Town of Smiths Falls
Public Works Operation Center
11 Air Care Drive
Smiths Falls ON, K7A 0B2

Date: July 29, 2026

PART 1 - General

- .1 This Addendum is issued prior to tender closing to provide revisions to the Contract Documents.
- .2 Such revisions shall become part of the Contract Documents and shall change the original contract documents only in the manner and extent stated.
- .3 Bidders shall take this Addendum into Consideration when preparing and submitting a Bid and shall acknowledge receipt of this Addendum in their bids.

1 MALE CHANGE ROOM 135 - PLAN
A703 1 : 25

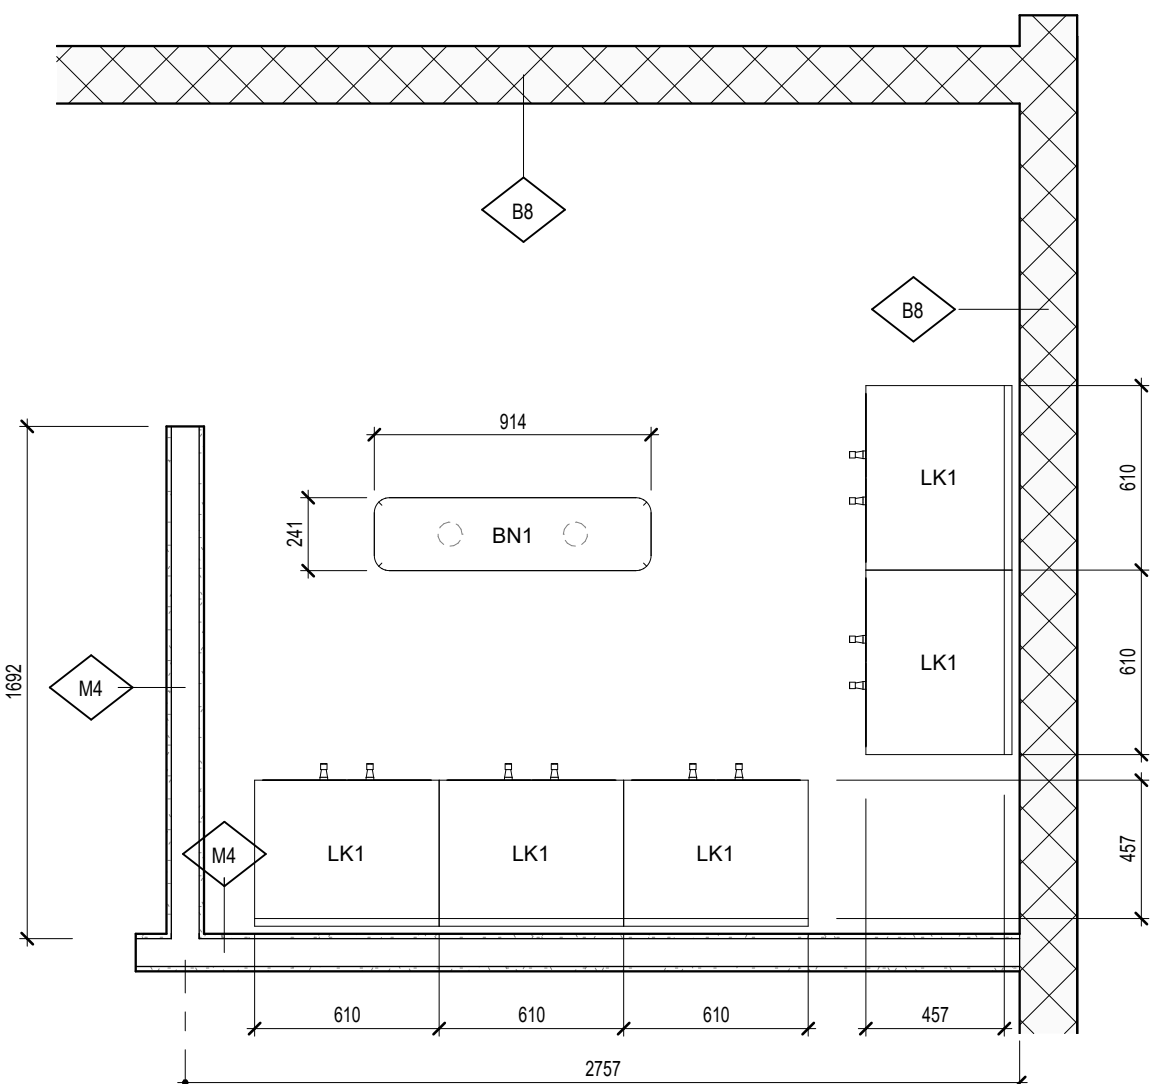
- .15 Refer to the attached Drawing A703 – OPS ENLARGED PLANS & ELEVATIONS:
 - .1 REVISE Wall-finish designations on the OPS washroom elevations.
 - .2 ADD Plan dimensions and REVISE bench depths at Male Change Room 135 and Female Change Room 130.

1 OFFICE - FINISHES PLAN
A902 1 : 50

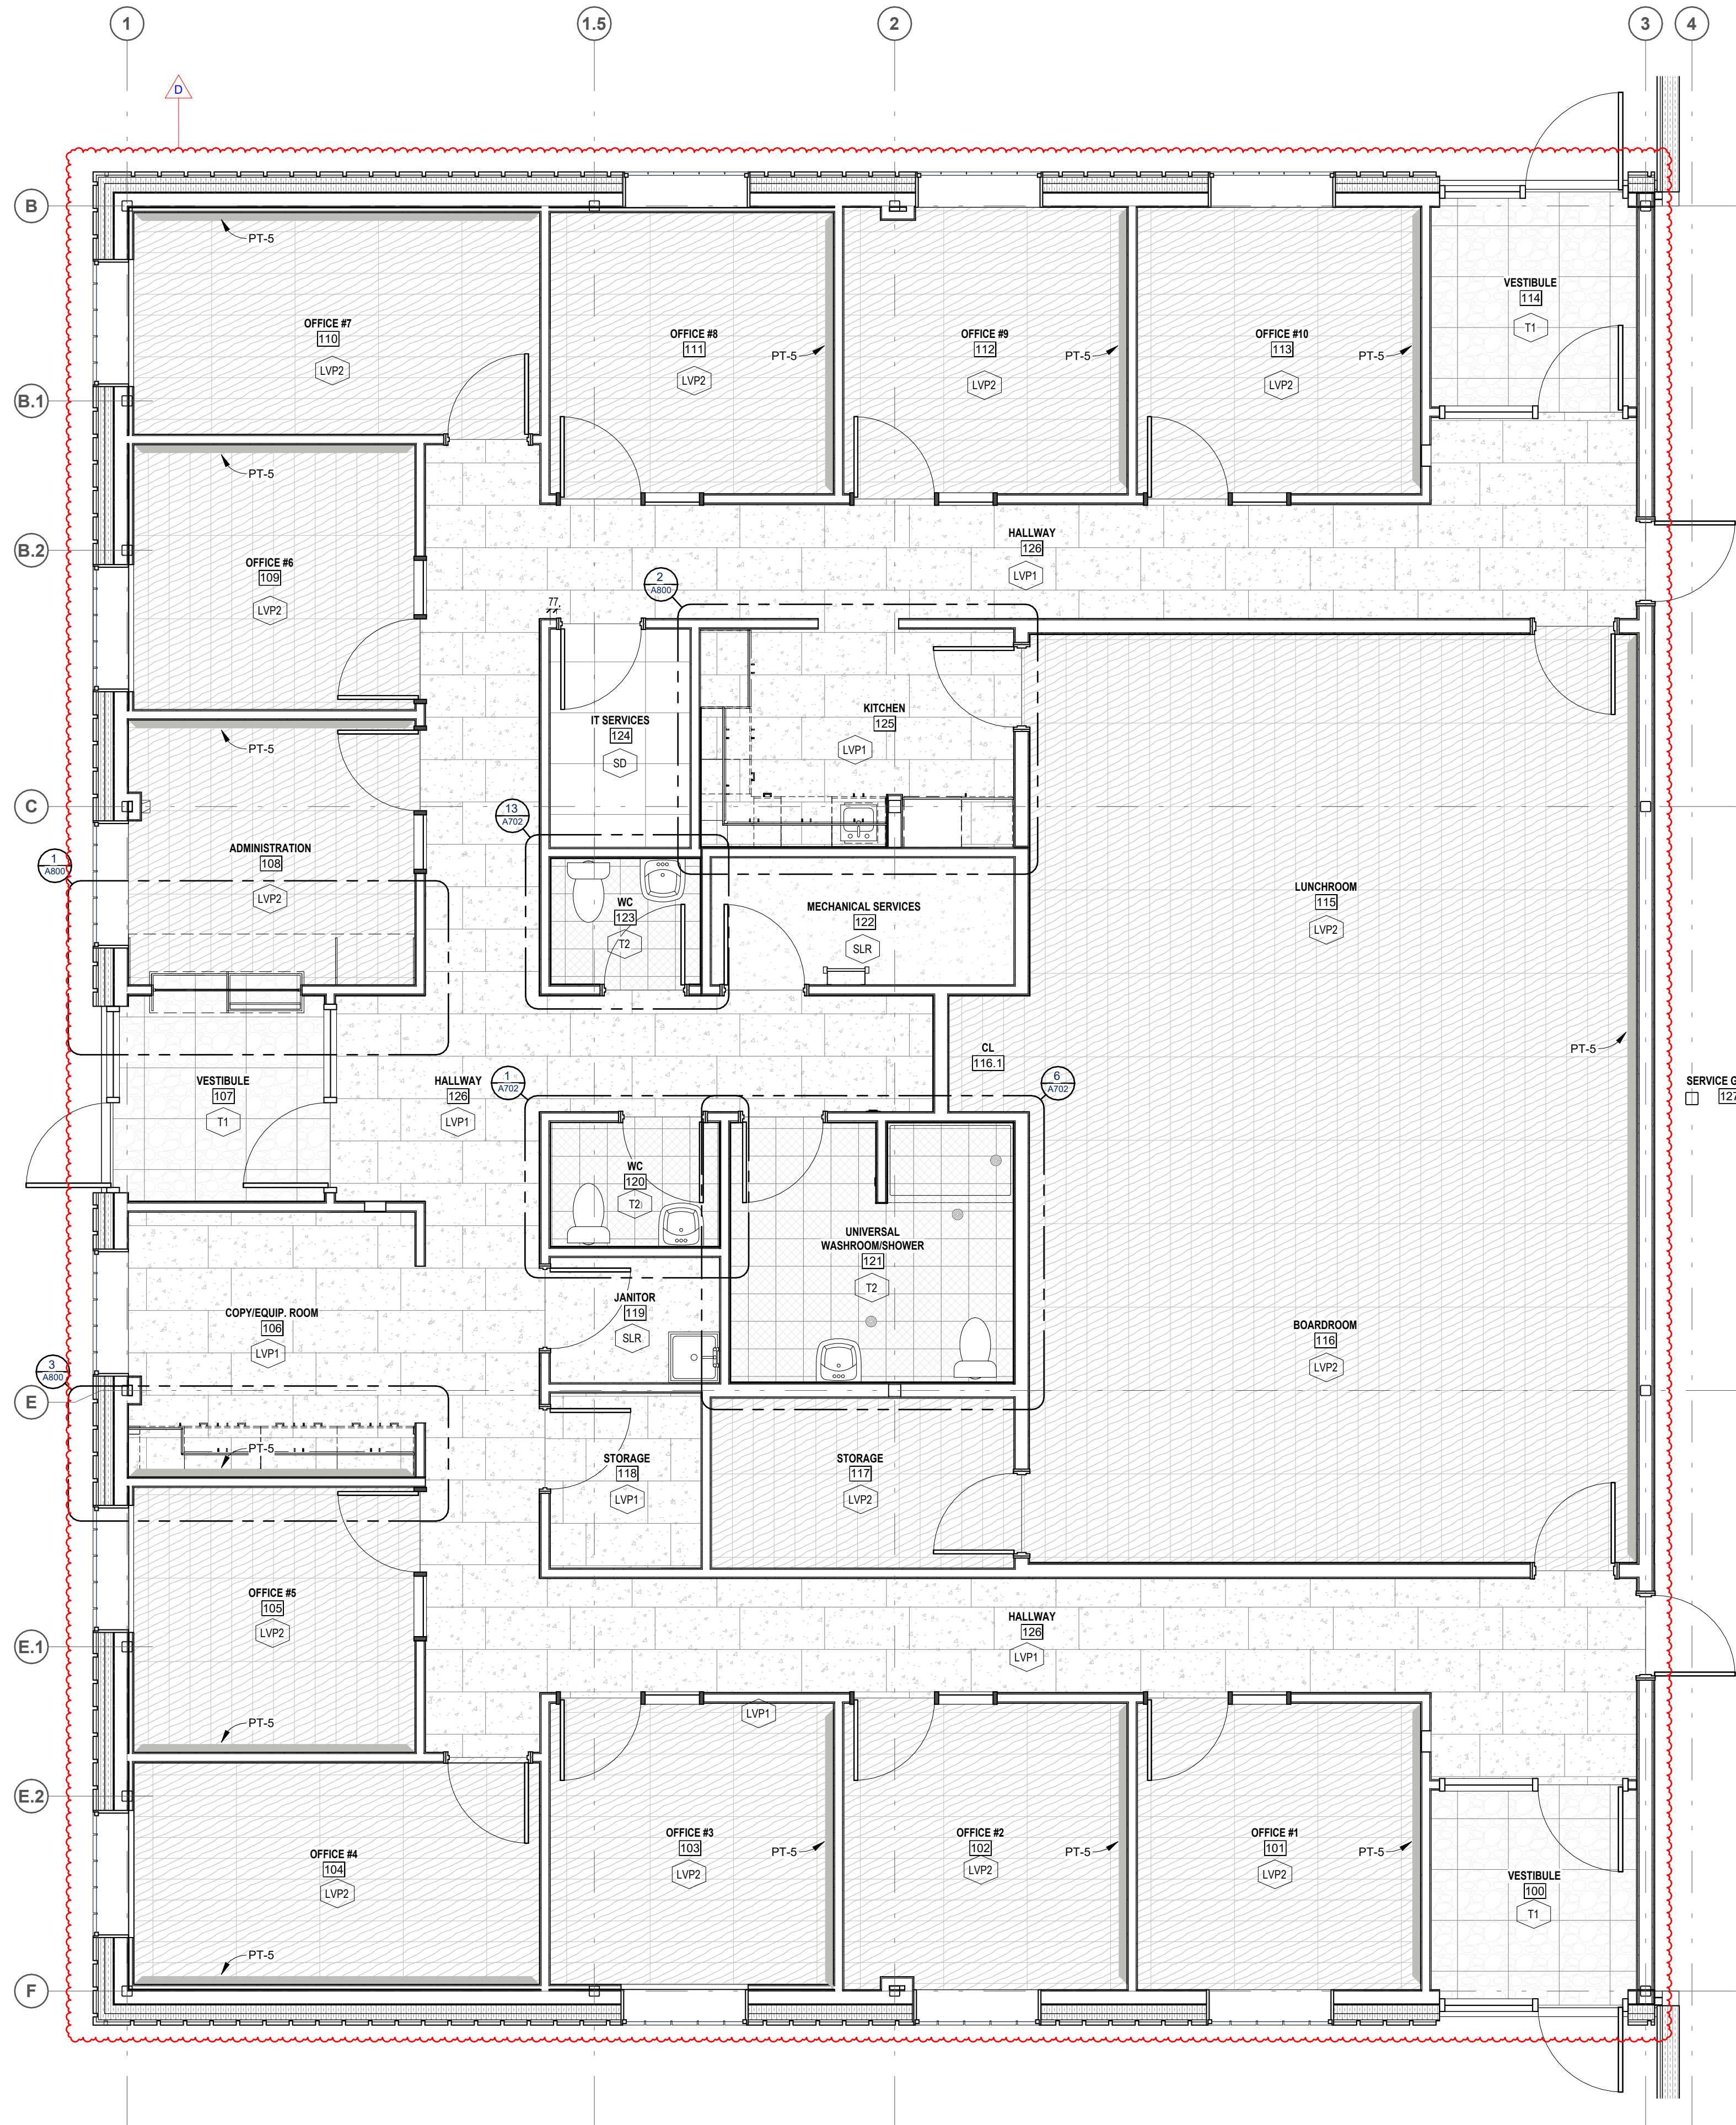
- .18 Refer to the attached Drawing A902 – ENLARGED FINISHES PLAN:
 - .1 REVISE Floor finish designations on the Office Finishes Plan.
 - .2 REVISE the Finishes Legend.
